Serial No. 09/974,845 Docket No. K-0332

Reply to Office Action of July 28, 2005

AMENDMENTS TO THE DRAWINGS:

FIG.1A Related Art

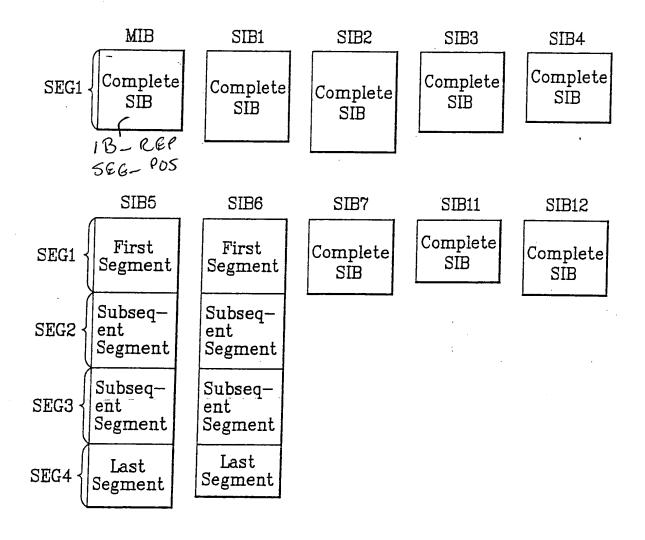
and 1B, the parameters IB_REP and SEG_POS have been added. In Fig. 1B, "246 bits" as

The Office Action objects to the drawings under 37 C.F.R. §1.84(p)(5) because they do not include reference signals described in the specification. The above amendments obviate the grounds for objection. More specifically, FIGs. 1A and 1B have been amended to include the parameters IP_REP and SEG_POS as requested. Still further, FIG. 2 has been amended to include the SFN counter as requested. Additionally, a control signal 45 has been labeled in FIG. 2 as requested. Withdrawal of the objections to the drawings under 37 C.F.R. §1.84(p)(5) is respectfully requested.

FIG.2

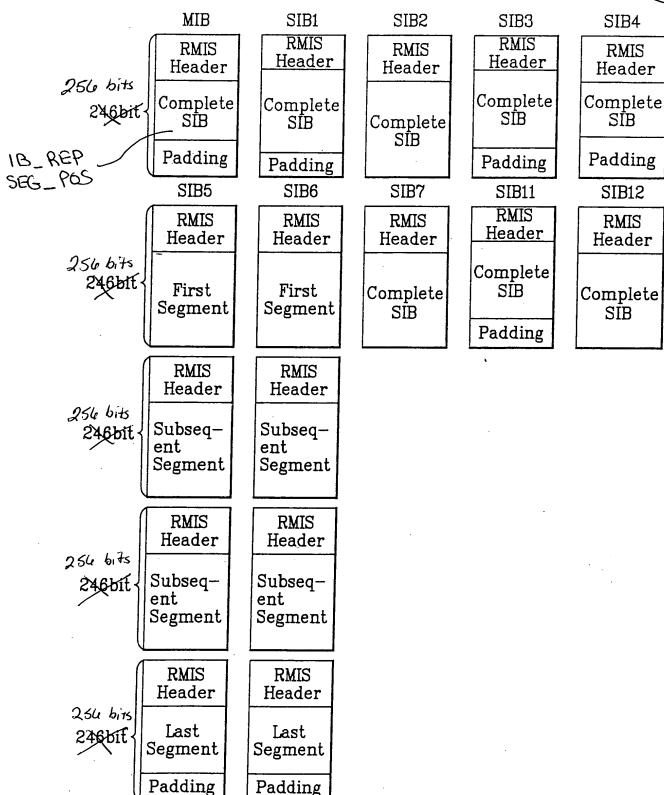
been changed to --256 bits--. In Fig. 2, an SFN counter has been provided within the micro

control part 30, and control signal 45 has been labeled.
